## ADDENDUM 1 - ABSTRACT FROM PAGE 2

### ADDENDUM 3 - ABSTRACT FROM PAGE 1

#### ADDENDUM 4

#### 1. When The Z80 Cannot Do A 68000 Bus Access

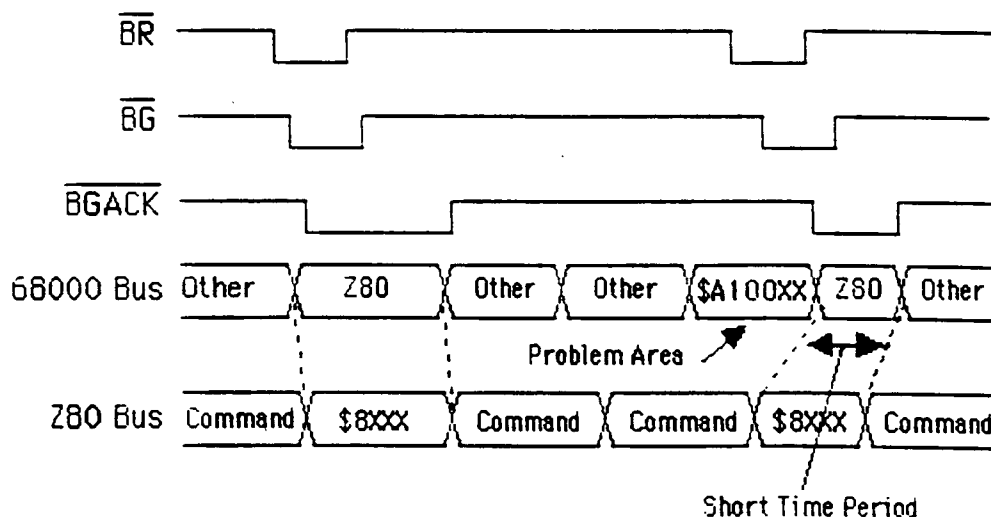
There are times when the Z80 cannot read or write good data in the 68000's addresses. If the 68000's bus cycle accesses \$A100XX prior to the Z80's interrupt, the bus cycle for the Z80 interrupt is shortened. When this occurs, the Z80 cannot read or write good data.

1. A BUSREQ is sent to the Z80. (Stops the Z80 bus access-\$A11100=0100H)
2. A100XX is accessed.
3. The BUSREQ from the Z80 is cleared. (The Z80 begins bus access-\$A11100=0000H)

Change the 68000's programs to follow the steps shown above.

#### Miscellaneous

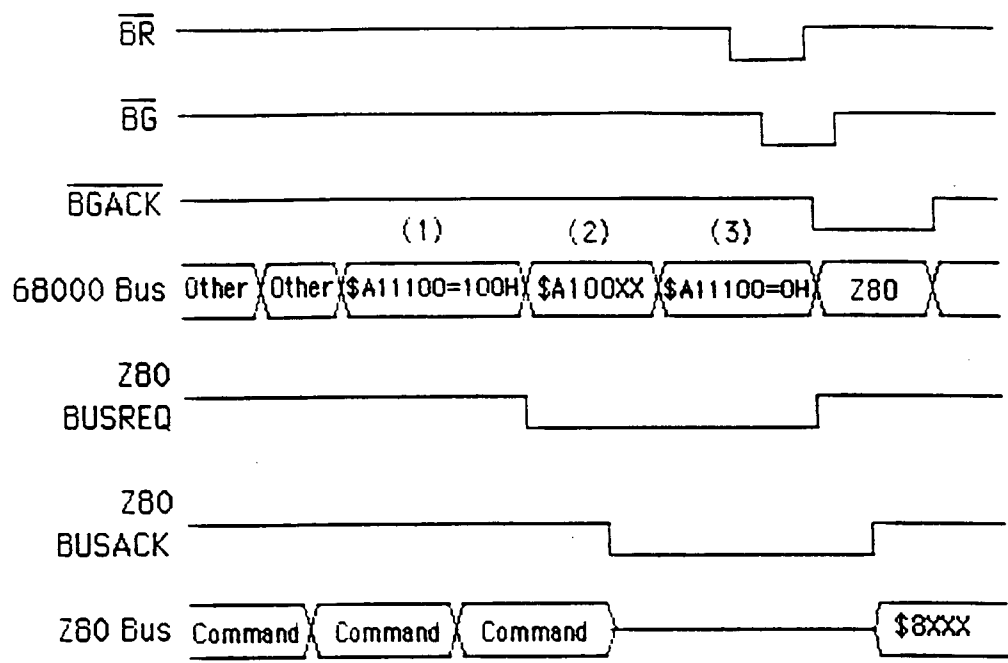
If the program structure uses something like V\_INT for sync, there should be no problems as long as it is set up so that unfavorable bus access patterns are not created.

#### 2. When Using H\_INT And V\_INT With A Genesis Program

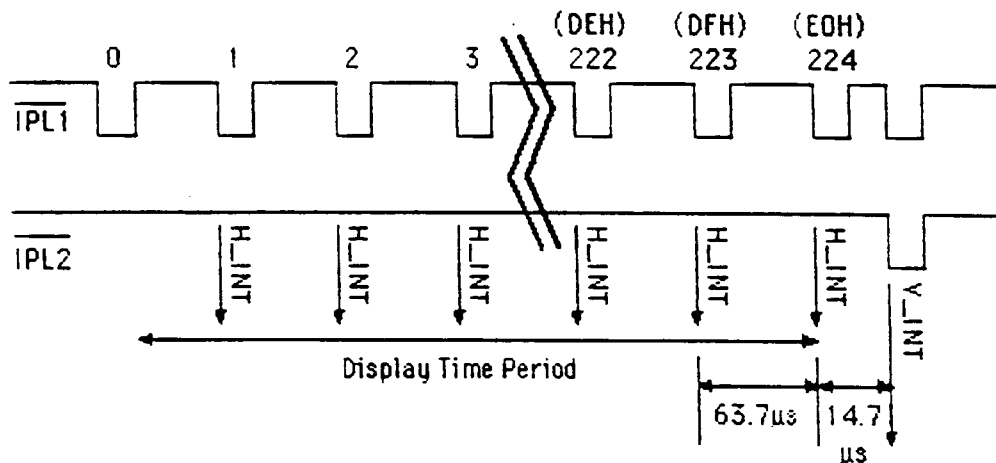
When the VDP register #0's IE1=1 and register #10=00H, H\_INT and V\_INT are created with the timing scheme described below. However, a problem occurs during No.224H\_INT's timing. Since the amount of time which is available before V\_INT is only 14.7 $\mu$ s, the acceptance of the No.224H\_INT means that the V\_INT will miss the V\_INT occurrence period. As a result, V\_INT is cancelled. Moreover, when the V\_INT is cancelled, the No.225H\_INT occurs instead of the V\_INT.

1. Set register #0's IE1=0 before No.223H\_INT ends in order to prevent No.224 from occurring.
2. Set register #0's IE1=1 before V\_INT is accepted in order to make H\_INT valid. (i.e., No.224 also becomes valid)
3. Process No.224H\_INT.

1. Set the 68000's SR=25XX before No.223H\_INT ends in order to prevent No.224 from being processed.<sup>1</sup>
2. Restore the 68000's SR prior to the end of V\_INT processing. (Enables No.224 processing)
3. Process No.224H\_INT.

**Diagram Of The Problem Caused By A Multiplication Command**

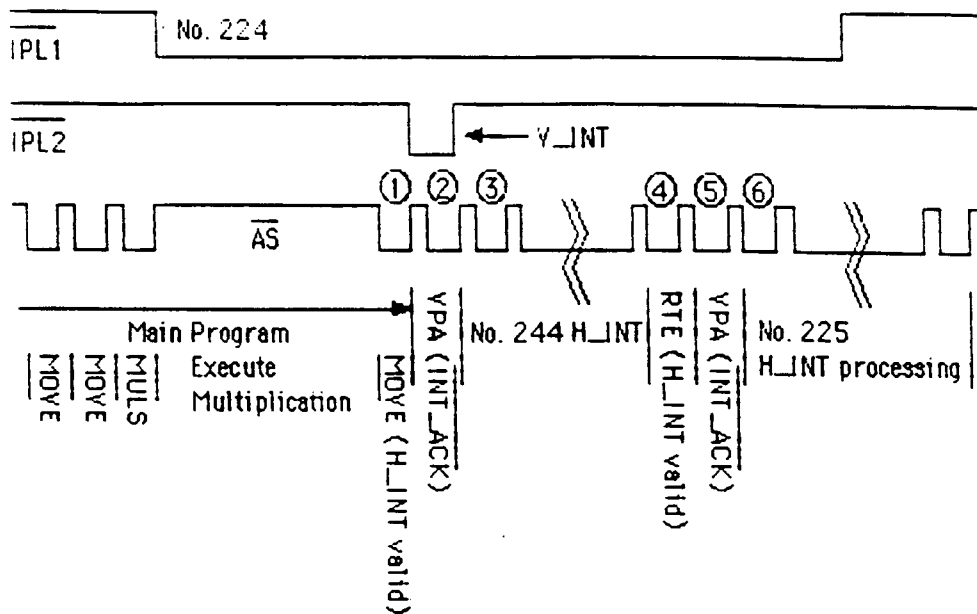
1. The MOVE command given after multiplication readies the 68000 to process H\_INT.
2. The 68000 creates a VPA (INT\_ACK). Since the VDP (for processing No.224) does not see a VPA after H\_INT occurs, H\_INT is not processed. After V\_INT occurs, the 68000 receives a VPA and mistakes this for V\_INT processing. H\_INT is stored.
3. Processing is executed since H\_INT (No.224) was received in Part 1.
4. Given a RTE after processing H\_INT, the 68000 readies to process H\_INT again.
5. The 68000 creates a VPA (INT\_ACK). The VDP (equivalent to No.225) processes the stored H\_INT.
6. Receiving H\_INT (No.225) in Part 4, processing occurs again.
